## ArevaEPRDCPEm Resource

**From:** WELLS Russell D (AREVA NP INC) [Russell.Wells@areva.com]  
**Sent:** Wednesday, May 20, 2009 3:03 PM  
**To:** Getachew Tesfaye  
**Cc:** Pederson Ronda M (AREVA NP INC); BENNETT Kathy A (OFR) (AREVA NP INC); DELANO Karen V (AREVA NP INC)  
**Subject:** Response to U.S. EPR Design Certification Application RAI No. 174, FSAR Ch 9, Supplement 3  
**Attachments:** RAI 174 Supplement 3 Response US EPR DC.pdf

**Subject:** Response to U.S. EPR Design Certification Application RAI No. 174, Supplement 2

**QUESTIONS for Balance of Plant Branch 1 (AP1000/EPR Projects) (SBPA)**

Figure 2.7.1.1—Component Cooling Water System Functional Arrangement  
Sheet 8 of 24

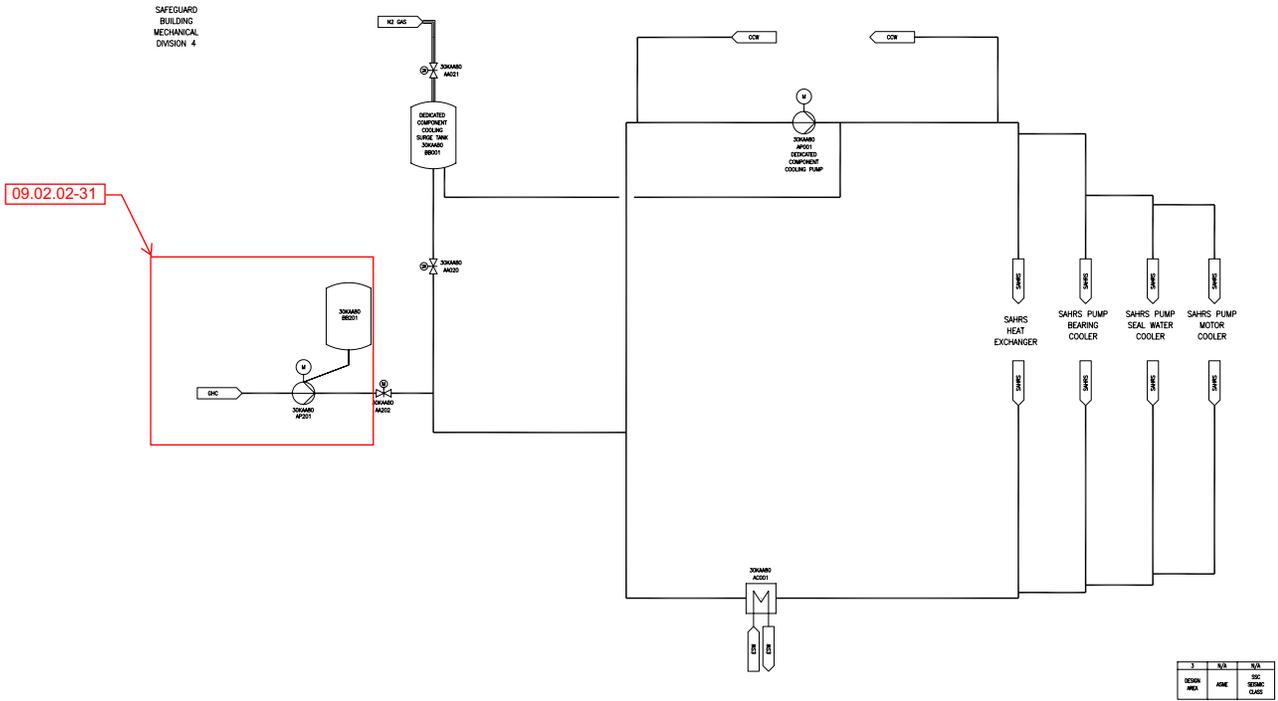
- l. KAA80 AP201 dedicated makeup pump missing from Tier 1 Figure 2.7.1.1.

- l. U.S. EPR FSAR Tier 1, Figure 2.7.1-1—Component Cooling Water System Functional Arrangement, Sheet 8 of 24, will be revised to include the dedicated makeup pump KAA80 AP201.
- m. Quantitative acceptance criteria have been provided for ITAAC as applicable. For design commitment 7.1, related to the CCWS heat exchanger capacity, the primary function of the heat exchangers is to transfer heat to the ESWS. For this commitment, it is not practical to test the design heat load, since it incorporates many heat loads associated with safety injection conditions. As stated in U.S. EPR FSAR Tier 1, Table 2.7.1-3—Component Cooling Water System ITAAC, ITAAC item 7.1:

Figure 2.7.1.1—Component Cooling Water System Functional Arrangement  
Sheet 11 of 24

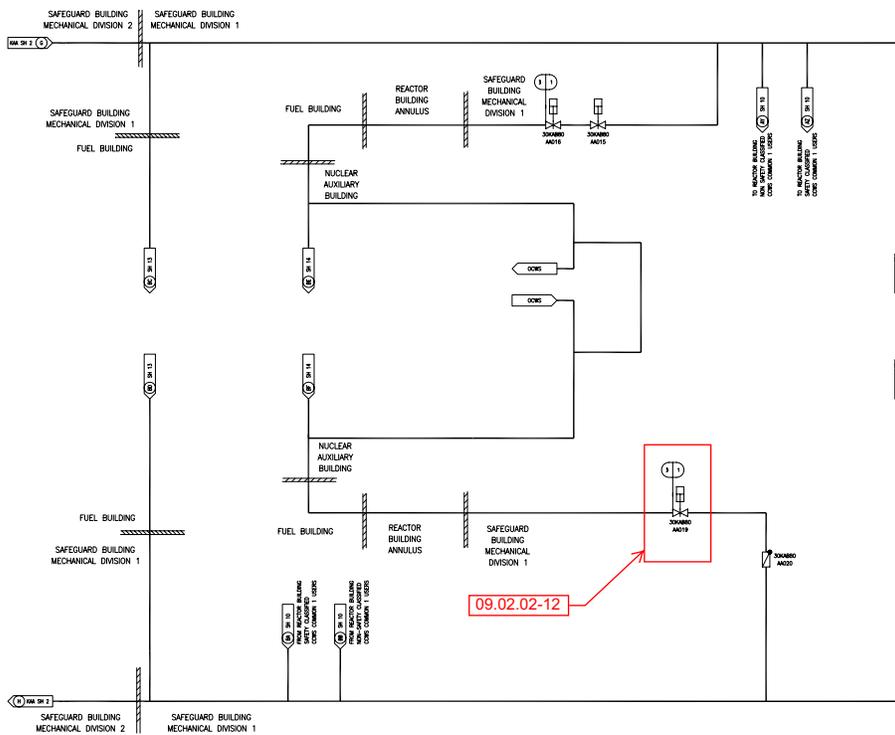
6. Provide a description and drawing of the common CCWS header cross-connect in FSAR Tier 2 Section 9.2.2 as well as in Tier 1 Sections 2.7.1.
7. Isolation valves for the non safety related (NSR) loads (1.b. header) in the nuclear auxiliary building (NAB) and radwaste building (RWB) are not all shown as hydraulic valves on FSAR Tier 1 Figure 2.7.1-1 and Tier 2 Figure 9.2.2-2 and 9.2.2-3. These drawings only show two hydraulically operated isolation valves (30KAB80 AA015 and AA016) in common header 1.b supply line to the operational chilled water system (OCWS) in the NAB. The return header isolation valves for this path include an motor operated valve (MOV) (30KAB80 AA019) and check valve AA020. In addition FSAR Tier 1 Table 2.7.1-2 (I&C/Electrical) indicates valve 30KAB80 AA019 is powered by division one. However, Tier 1 Mechanical Design Table 2.7.1-1 and Tier 2 IST Table 3.9.6-2 list valve 30KAB80 AA019 as hydraulically operated.

U.S. EPR FSAR Tier 1, Figure 2.7.1-1—Component Cooling Water System Functional Arrangement, Sheet 11 of 24, and U.S. EPR FSAR Tier 2, Figure 9.2.2-2—Component Cooling Water System Common Loop 1, Sheet 1 of 7, will be revised to indicate valve KAB80 AA019 is hydraulically operated.

Figure 2.7.1-1—Component Cooling Water System Functional Arrangement  
Sheet 15 of 24

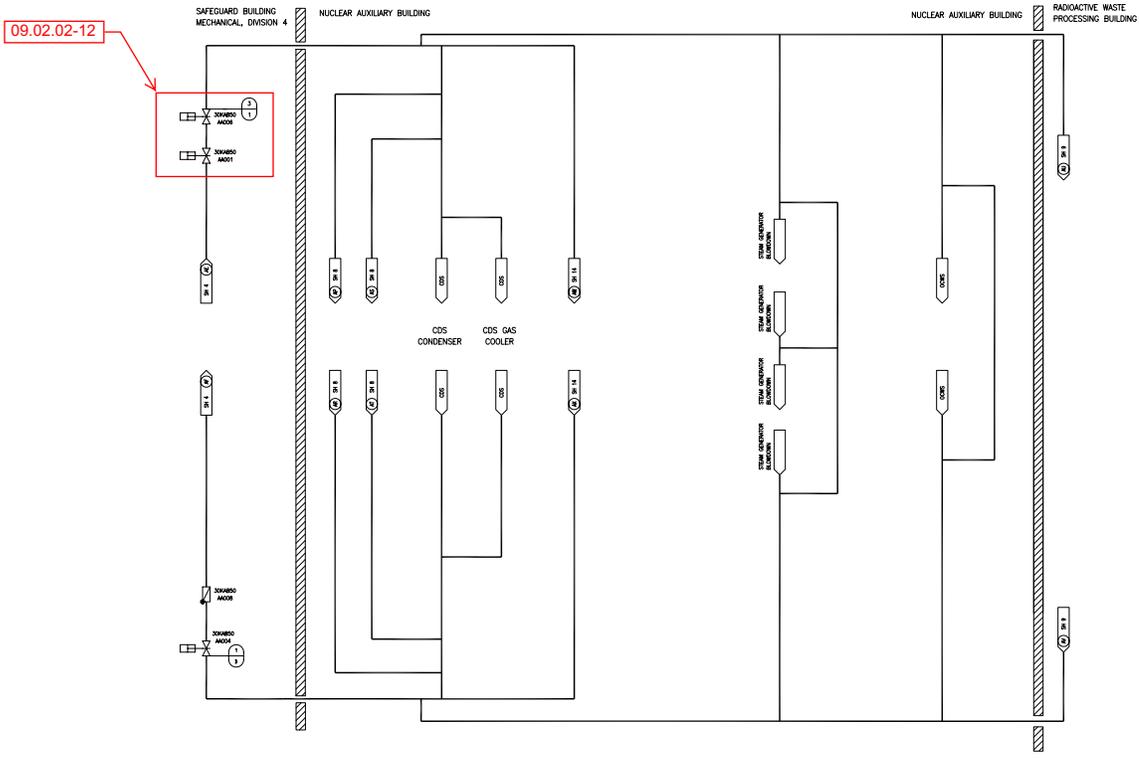
8. Both of the common header 2.b SR supply isolation valves (30KAB50 AA001, AA006) for the NSR loads in the NAB and RWB are identified as motor operated (MOV) by FSAR Tier 1 Figure 2.7.1-1 and Tier 2 Figure 9.2.2-3. However, FSAR Table 3.9.6-2 (Valve IST) identifies valve 30KAB50 AA001 as hydraulically operated and does not include valve 30KAB50 AA006. Note that the corresponding return isolation valves are 30KAB50 004 (correctly shown as hydraulically operated) and check valve 30KAB50 008. For these valves Tier 1 Table 2.7.1-1 does not identify the operator type, however, Table 2.7.1-2 indicates that the three valves with operators are powered from 1E division four. The following considerations need to be addressed:

U.S. EPR FSAR Tier 1, Figure 2.7.1-1—Component Cooling Water System Functional Arrangement, Sheet 15 of 24, and U.S. EPR FSAR Tier 2, Figure 9.2.2-3—Component Cooling Water System Common Loop 2, Sheet 6 of 8, will be revised to indicate valves KAB50 AA001/006 are hydraulically operated.
